DT12 Transmission Control Harness Chafing the Transmission Control Module

26-054

Freightliner
Service Bulletin

Description of Revisions: *This bulletin replaces the version dated 12/08/2021. An additional part number (23-13477-000) was added to Fig. 3 and Table 1. Steps 4 and 5 have been added.*

Fig. 1, Improved Transmission Control Harness Routing

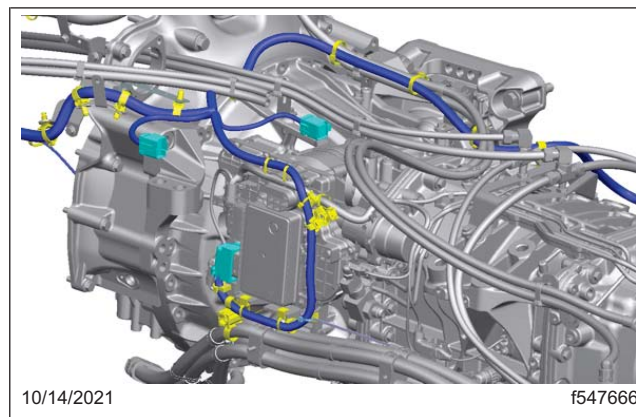
The routing and clipping design has changed to prevent this issue. This new design can be applied to vehicles in the field to prevent future problems.

Follow the procedure below to install the improved transmission control harness routing, as shown in [Fig. 1](#).

Fig. 2, Tie Straps in Original DT12 Transmission Harness Routing

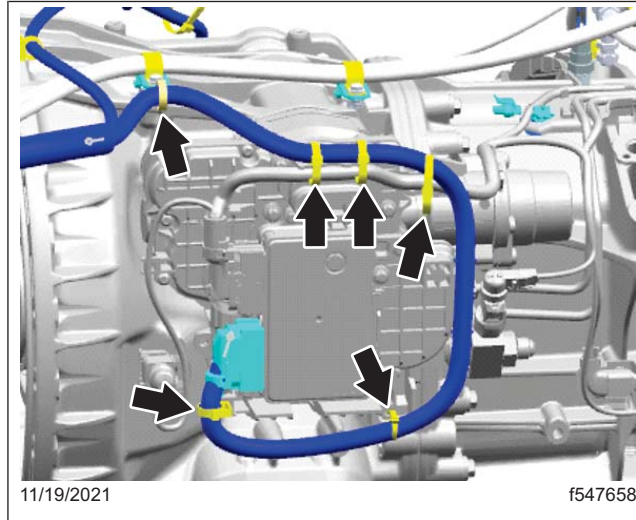
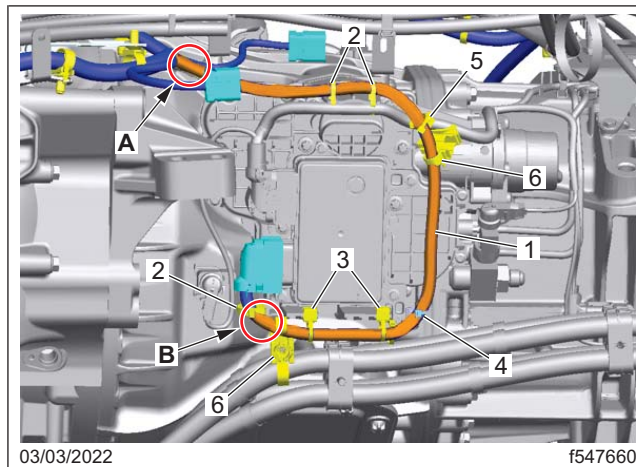
1. Park the vehicle on a level surface, turn the steer tires all the way to the right, shut down the engine, and set the parking brake. Chock the tires.
2. Open the hood.
3. Disconnect the negative battery cable.
4. Remove the splash shield. See **Group 31** of the applicable vehicle workshop manual.
5. Remove the splash shield bracket and separate it from the air and electrical harness.
6. Remove the six clipping points that attach the transmission leg of the chassis harness, from the Y near the bell housing to the TCM connector, as shown in [Fig. 2](#). If harness repair is needed, refer to **SB 54-290** for detailed instructions.

Fig. 4, Securing the Harness Clipping Point at the TCU Connector

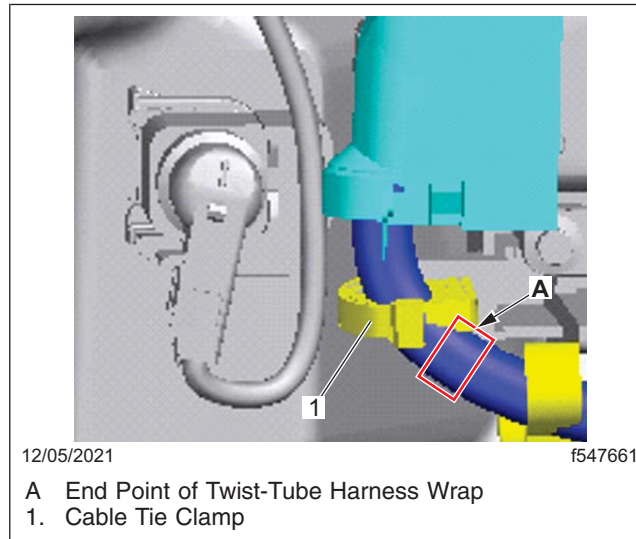
- 7.1 Route the harness along the path, and install the harness connector on the transmission control unit (TCU).
- 7.2 Secure the harness clipping point next to the TCU connector using a cable tie clamp, as shown in [Fig. 4](#).

Fig. 5, Attaching the Harness to the Shift Controller with Edge Clip Ties

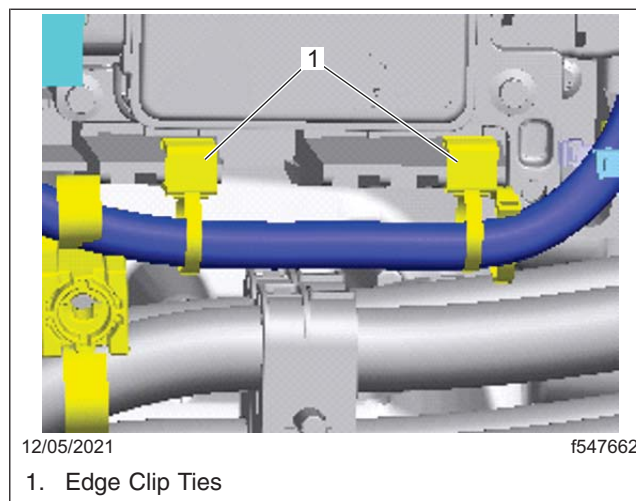
- 7.3 Secure the harness to the shift controller under the TCU, using the edge clip ties, as shown in [Fig. 5](#).

Fig. 6, Attaching the Harness at the Rear of the TCU with an Edge Clip Tie

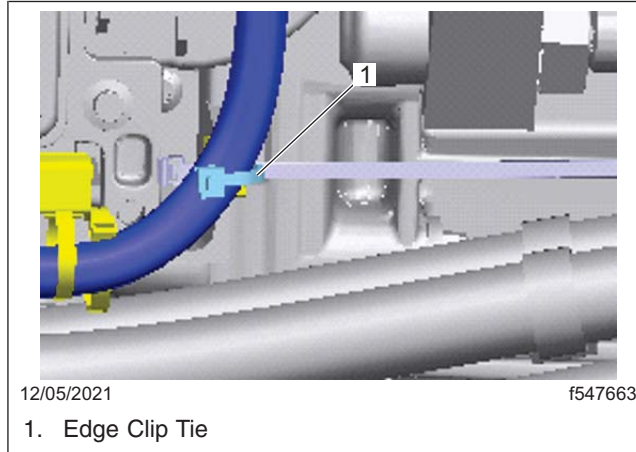
- 7.4 Using an edge clip tie and clamp, secure the harness on the lower tab at the rear of the TCU. See [Fig. 6](#).

Fig. 7, Installing Cable

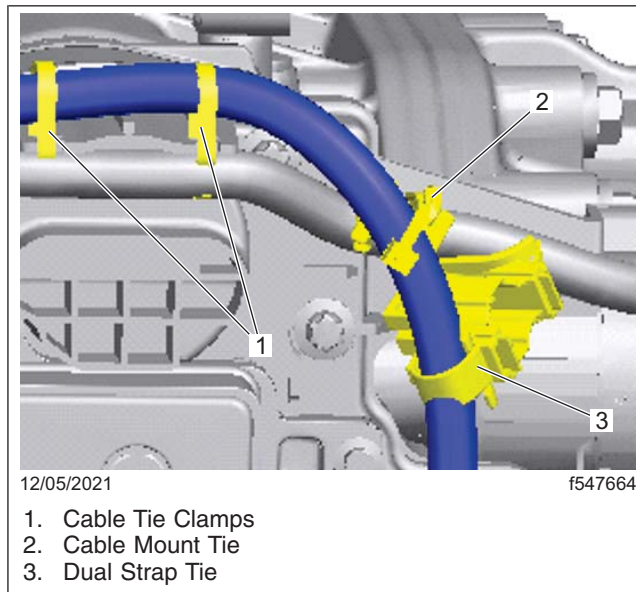
7.5 Install all the ties at the top of the shift controller, as shown in [Fig. 7](#).

- 7.6 Install a dual tie (item 3) to separate the transmission and chassis harness, and prevent the chassis harness from touching the shift controller.
- 7.7 Install a single tie (item 2) to secure the chassis harness to the outside of the transmission harness clipping point.
- 7.8 Install two cable tie clamps (item 1) at the top of the shift controller to secure the transmission harness.

Fig. 8, Installing a Second (Optional) Dual Strap Tie

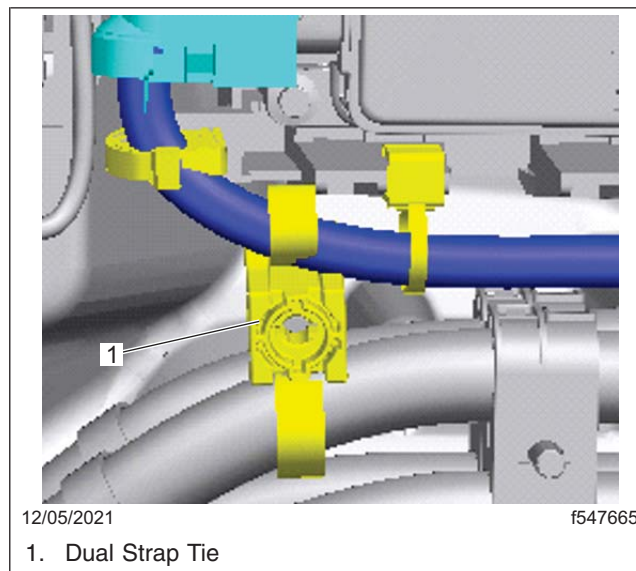
9. For C- or D-box transmissions with battery cables that route over the power take off (PTO) port and have a cable in the top outboard routing track, install the second dual strap tie on the added harness wrap zone, between the TCU connector support tie and the forward C-clip tie. See **Fig. 8**.
